Project No. 0690046-003-AC

Pursuant to discussions with Florida Department of Environmental Protection ("DEP" or "Department") staff, this application is being submitted to amend and replace Prevention of Significant Deterioration (PSD) Permit No. AC 35-115379 (PSD-FL-113) for Ogden Martin Systems of Lake, Inc. ("OMSL").

**Application to Amend
Construction Permit No. PSD-FL-113
For Ogden Martin Systems of Lake, Inc.**

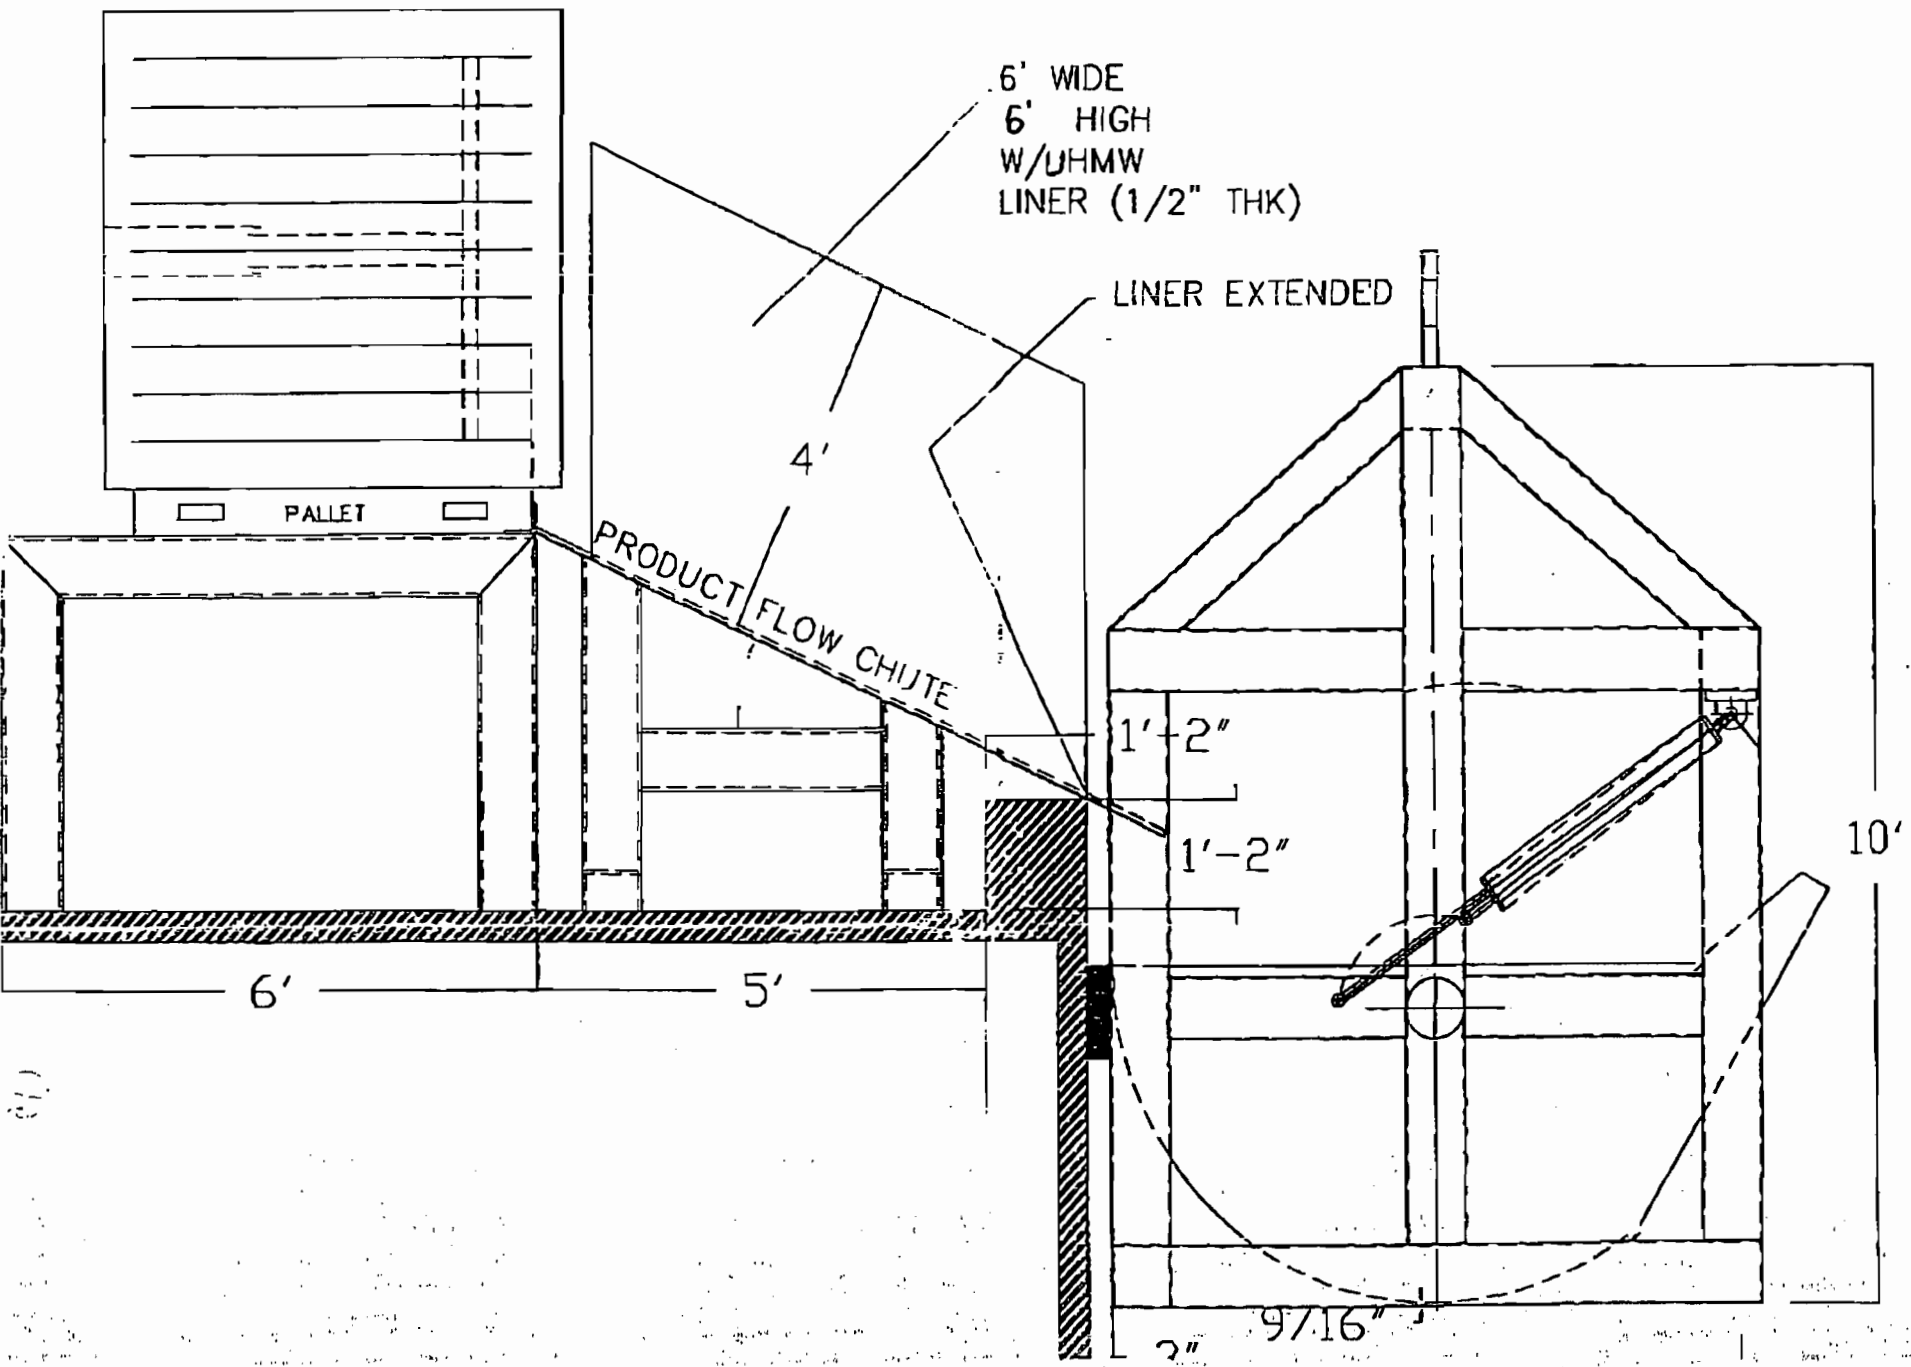
Attached, please find a preliminary drawing of the bucket. We believe that this system, used in conjunction with the existing conveyor, will enhance the facility's already excellent safety record. Thanking you in advance for your assistance in this matter, we look forward to your final guidance. If additional information is needed, please contact me at (352) 365-1611.
